<b>Docket Number:</b>	08-AFC-09C
<b>Project Title:</b>	Palmdale Energy Project (Formerly Palmdale Hybrid Power Plant) - Compliance
<b>TN #:</b>	215189
<b>Document Title:</b>	Palmdale Energy LLC's Opening Testimony
<b>Description:</b>	N/A
<b>Filer:</b>	Marie Fleming
<b>Organization:</b>	DayZen LLC
<b>Submitter Role:</b>	Applicant Representative
<b>Submission Date:</b>	1/6/2017 4:22:21 PM
<b>Docketed Date:</b>	1/6/2017

Palmdale Energy, LLC's Opening Testimony

Palmdale Energy Project (08-AFC-09C)

**PALMDALE ENERGY, LLC  
PALMDALE ENERGY PROJECT  
PROJECT DESCRIPTION  
OPENING TESTIMONY**

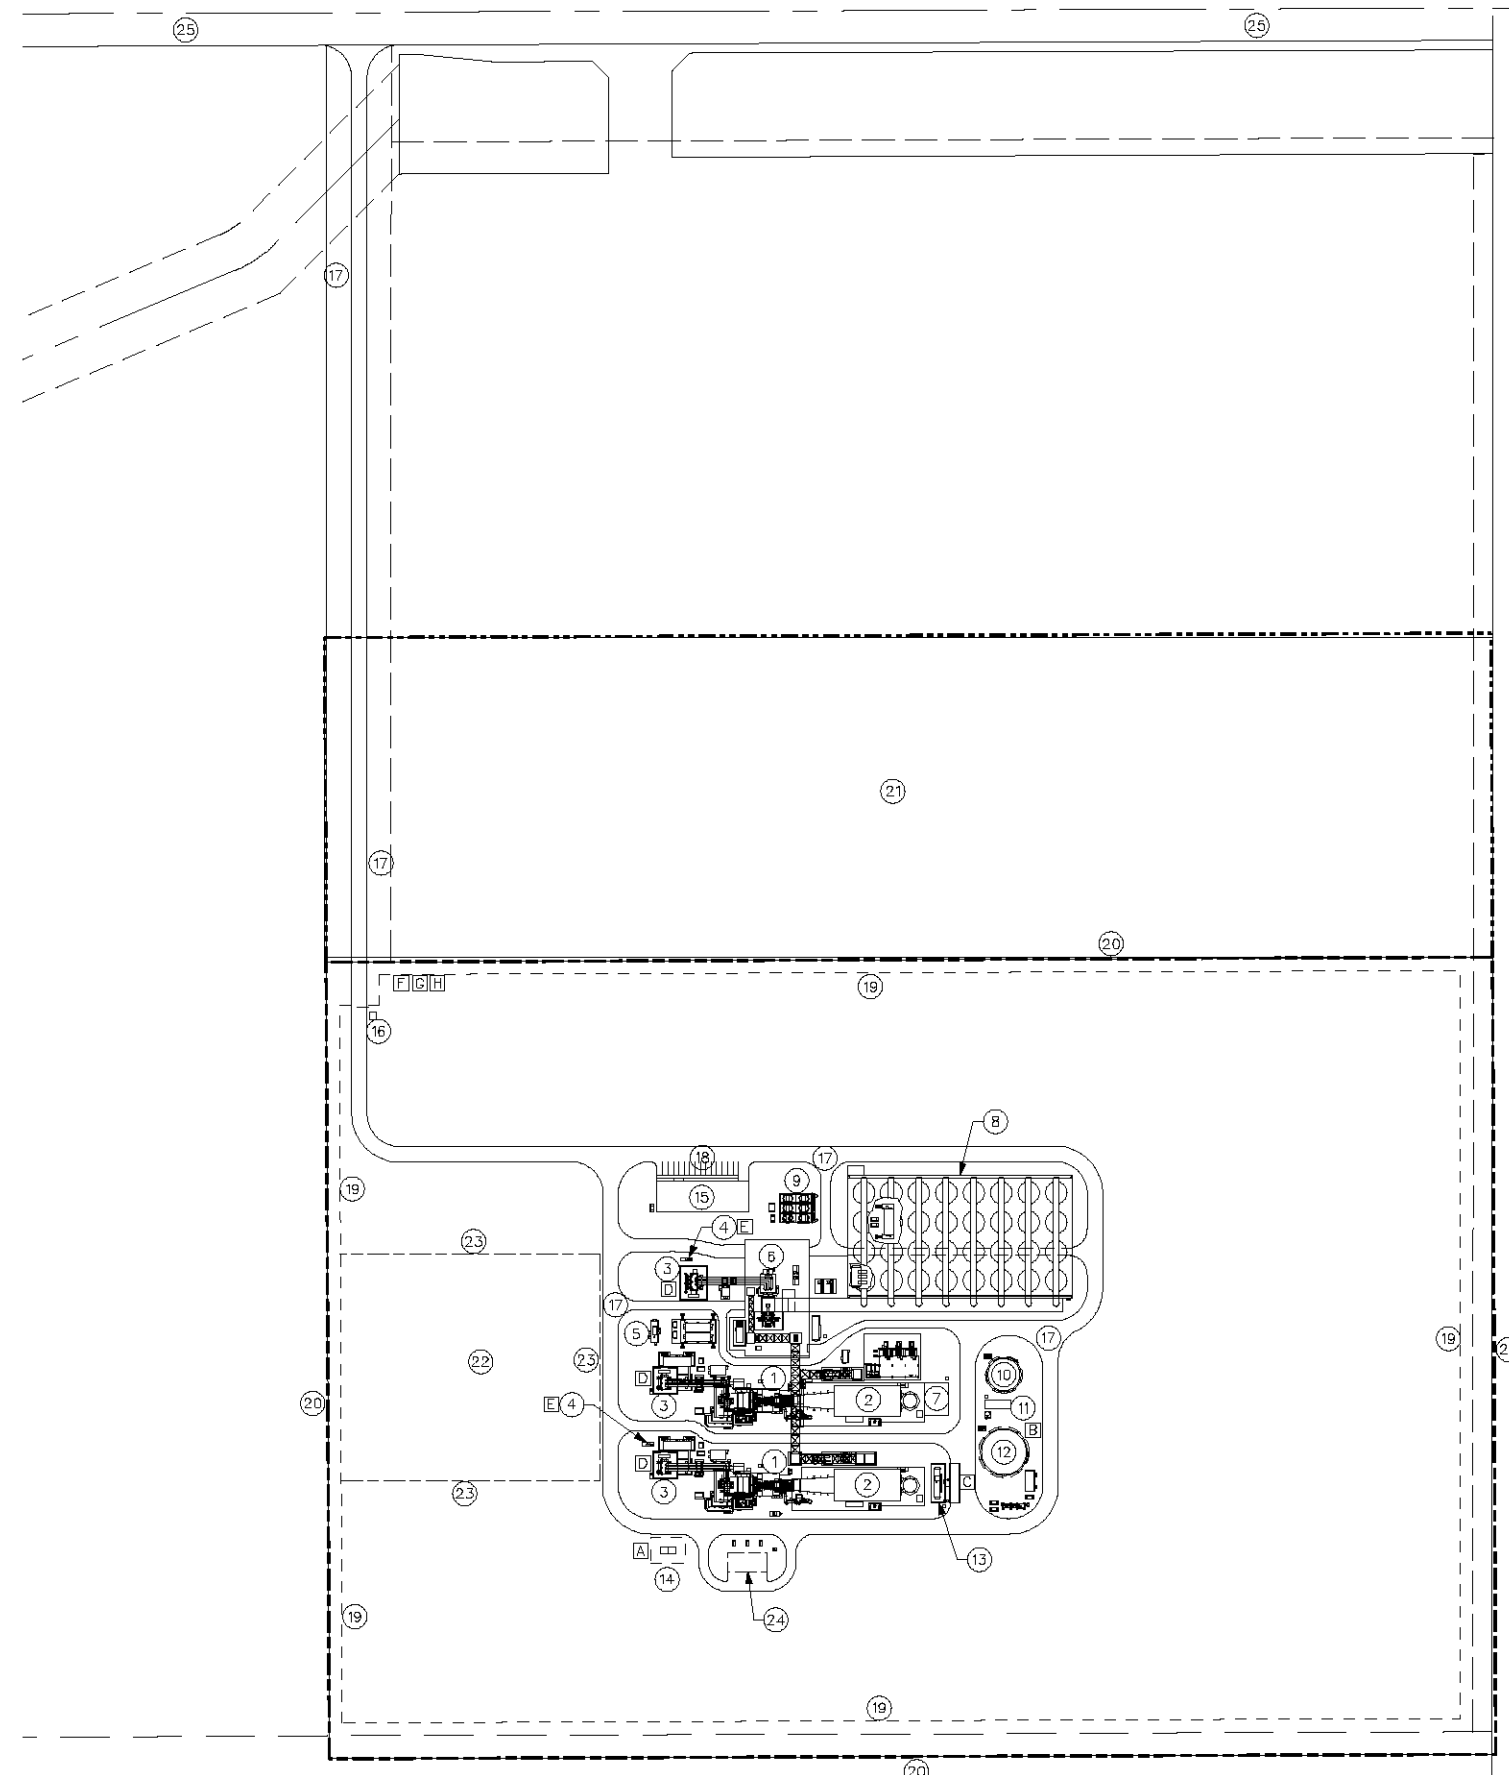
Figure 2 at the end of the Project Description section of the FSA does not accurately show the PEP. We request that the Final Decision simply include Figure 2-1 included in Revised Petition For Amendment, which shows a more detailed depiction of the modifications proposed by the PEP.

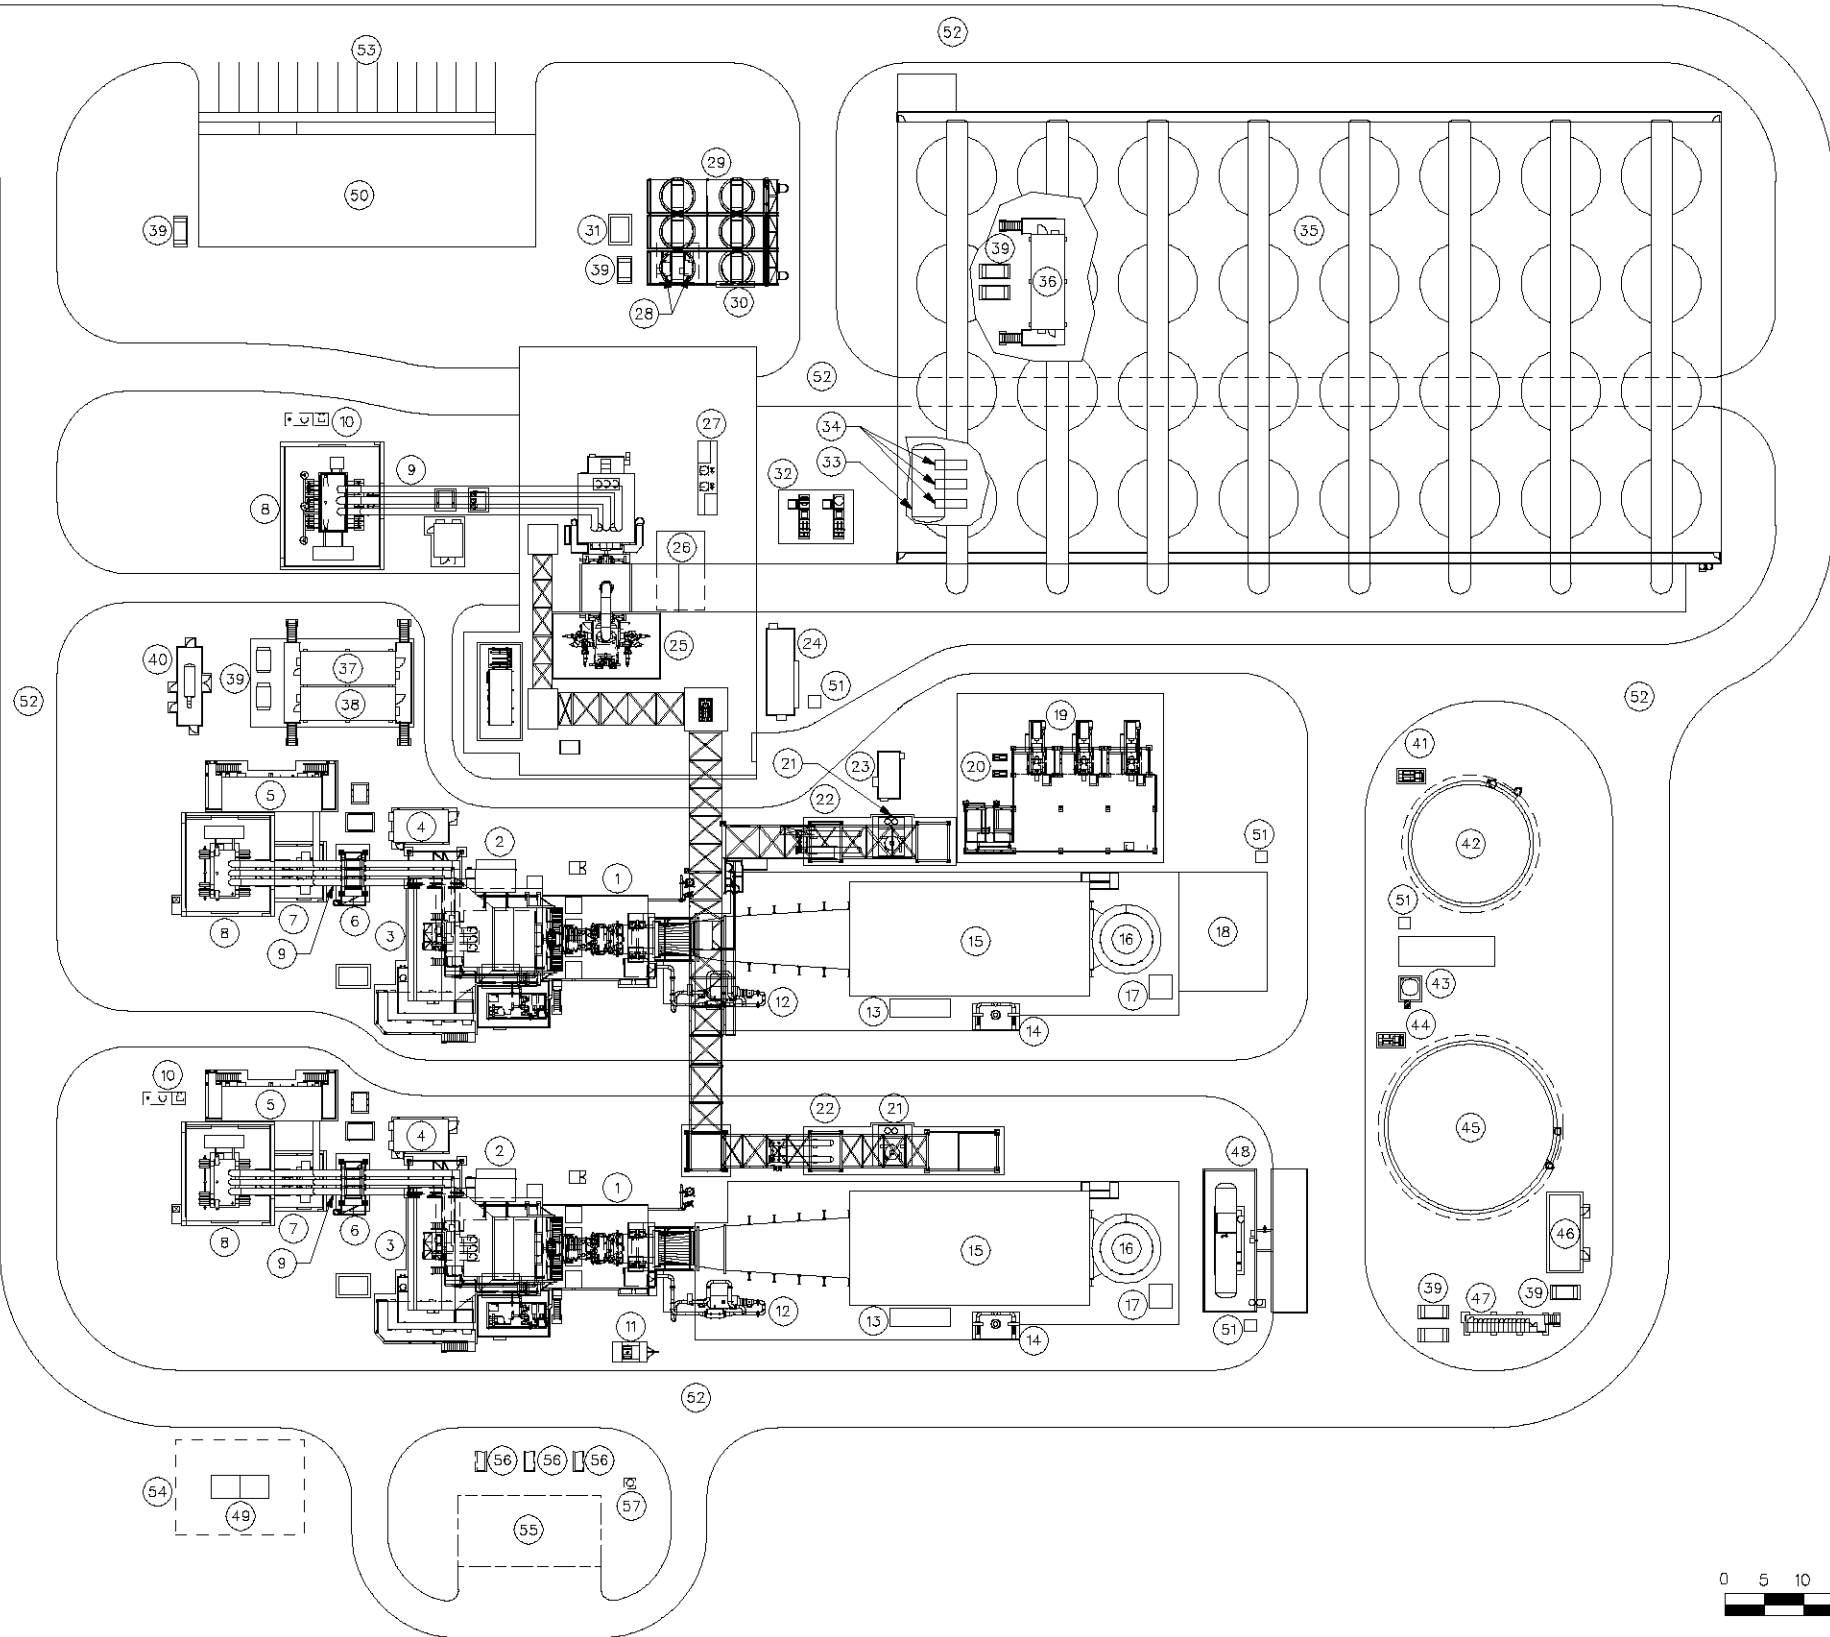
In addition, in our review of the Final Staff Assessment, we noticed that the Natural Gas Compression Equipment, which is necessary to ensure that minimum facility natural gas pressures are met when Southern California Gas is not able to deliver natural gas at the required pressure levels, is not described in the project description materials. Therefore we are providing updated materials, attached to this Project Description Testimony. This equipment has always been part of the Project, just not adequately described. This equipment is included in facility noise calculations and therefore no changes to the analysis or Noise Conditions of Certification are required.

1. The (2x1 5000F TKY Site Plan) drawing replaces the Petition For Amendment *Figure 2-3 Plot Plan*.
2. (2x1 5000F TKY GA) drawing replaces the Revised Petition For Amendment *Figure 2-4 General Arrangement*. Item #55 represents the Natural Gas Compression Equipment.
3. Updated *Exhibit 2-A – Equipment Dimensions*.

We request that the Final Decision utilize the updated Site Plans, attached, which identify the Natural Gas Compression Equipment.

Redundant gas compressors, either 3x50% or 2x100%, will be provided to increase gas pressure from pipeline pressure to that need for the gas turbines at those times when pipeline pressure is less than the minimum pressure required by the gas turbines. The gas compressors will be located in individual acoustic enclosures or a common building/enclosure. The compressors will be powered by electric motors; the maximum required compression power is estimated to be approximately 3800 horsepower.
